UNITED STATES PATENT AND TRADEMARK OFFICE

APPLICATION NO.	FILING DATE	FIRST NAMED INVENTOR	ATTORNEY DOCKET NO.	CONFIRMATION NO.
10/626,592	07/25/2003	Takeshi Matsunaga	240900US2S	9746
22850	7590	06/14/2005	EXAMINER	
OBLON, SPIVAK, MCCLELLAND, MAIER & NEUSTADT, P.C. 1940 DUKE STREET ALEXANDRIA, VA 22314			ORTIZ, EDGARDO	
			ART UNIT	PAPER NUMBER
			2815

Office Action Summary

FIG. 1

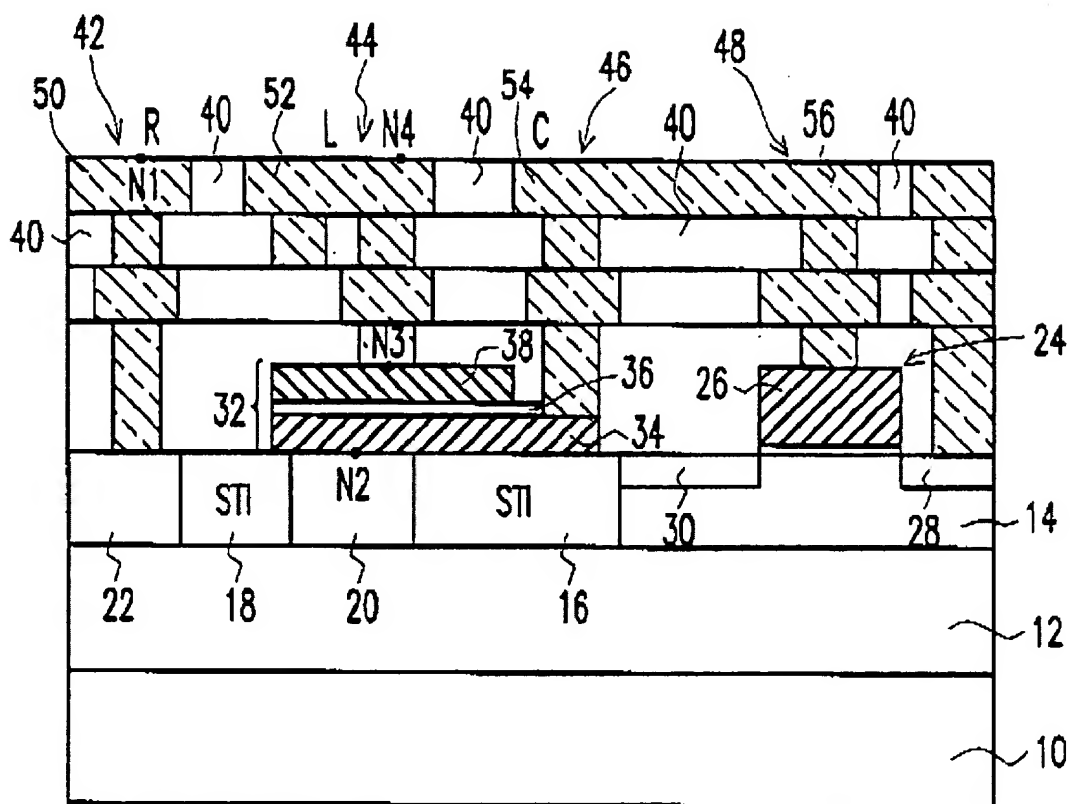
1. Claims 1, 3 and 7 are rejected under 35 U.S.C. 102(e) as being anticipated by Yeh et al. (U.S. Patent No. 6,294,834). With regard to Claim 1, Yeh discloses on figure 1 a semiconductor device, comprising: a multilayer wiring structure including a plurality of wiring layers formed on a substrate (10), a capacitor (32) arranged in a predetermined wiring layer in the multilayer wiring structure and including a lower electrode (34), a dielectric film (36), and an upper electrode (38), a first via formed in the predetermined wiring layer and connected to a top surface of the upper electrode (38) of the capacitor, and a second via formed in an overlying wiring layer stacked on the predetermined wiring layer, the second via formed on the first via and the second via being connected to a wiring formed in the overlying wiring layer. For the purpose of further illustrating the teachings of Yeh, figure 1 is reproduced herein.

With regard to Claim 3, Yeh discloses that the predetermined wiring layer has a third via formed on the lower electrode (34) and a wiring connected the third via and buried in a surface of the predetermined wiring layer. See figure 1.

With regard to Claim 7, Yeh discloses that the overlying wiring layer has a wiring connected to a top of the second via and buried in a surface of the overlying wiring layer. See figure 1.
